DOC #	PROCESS NAME	PAGE	REVISION	STATION	BY	DATE
AR839	Upper Shock/Track Bar Mount Replacement	1 OF 1		SER-E	C.WARD	6/19/2017

Complaint: Cracking at Upper Shock and Track Bar Mounts on Chassis Frame

ASSEMBLY, FRAME, 191 WB, SOM SUSP REINF

RS RETROFIT INSTALLATION

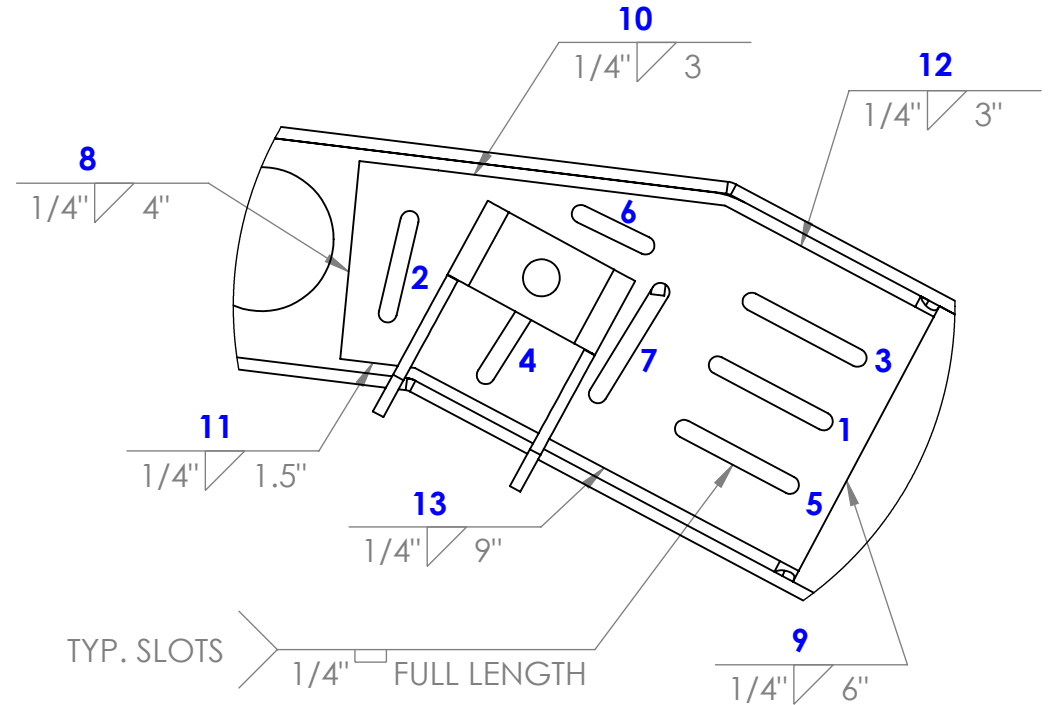
- REMOVE ALL EXISTING BRACKETS
- DRILL STOP ANY FRAME CRACKS AND FILL WITH WELD. GRIND SURFACE SMOOTH
- PLACE RS RETROFIT BRACKET, AS SHOWN. THERE SHOULD BE A 1/4" SPACE ABOVE AND BELOW FOR CLEARANCE AROUND EXISTING WELD BEADS
- WITH BRACKET FLAT AGAINST FRAME, CLAMP AND WELD AS SHOWN IN FIGURE 1.

CS RETROFIT INSTALLATION

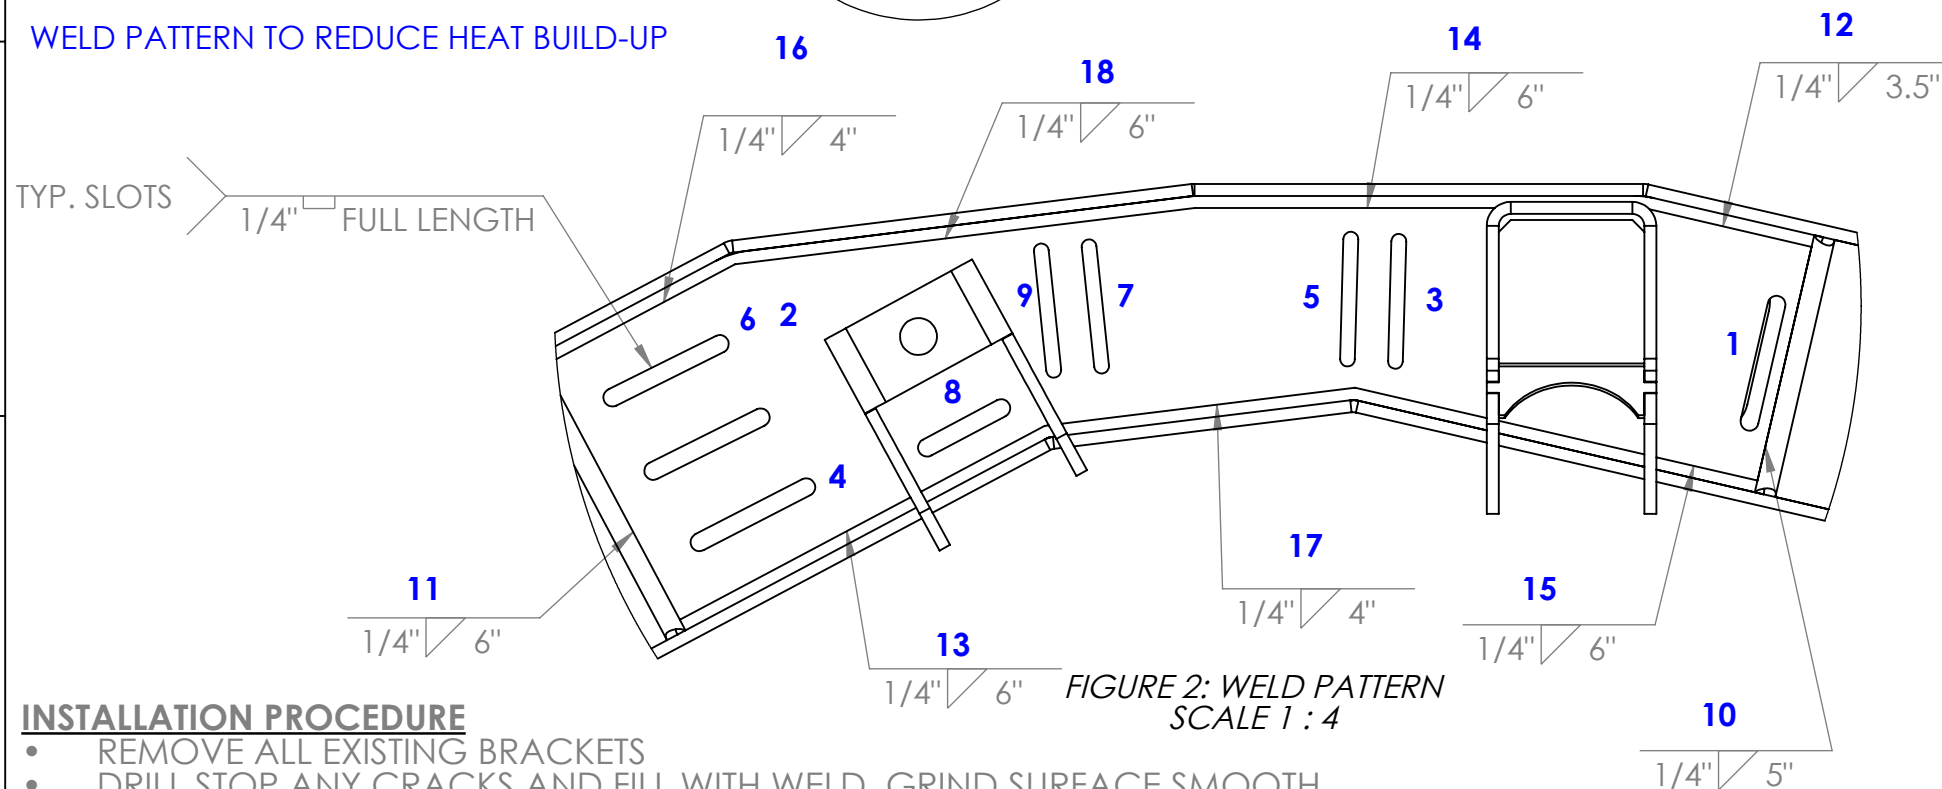
- REMOVE ALL EXISTING BRACKETS
- DRILL STOP ANY CRACKS AND FILL WITH WELD. GRIND SURFACE SMOOTH
- PLACE CS RETROFIT BRACKET, AS SHOWN. THERE SHOULD BE A 1/4" SPACE ABOVE AND BELOW FOR CLEARANCE AROUND EXISTING WELD BEADS
- WITH BRACKET FLAT AGAINST FRAME, CLAMP AND WELD AS SHOWN IN FIGURE 2.
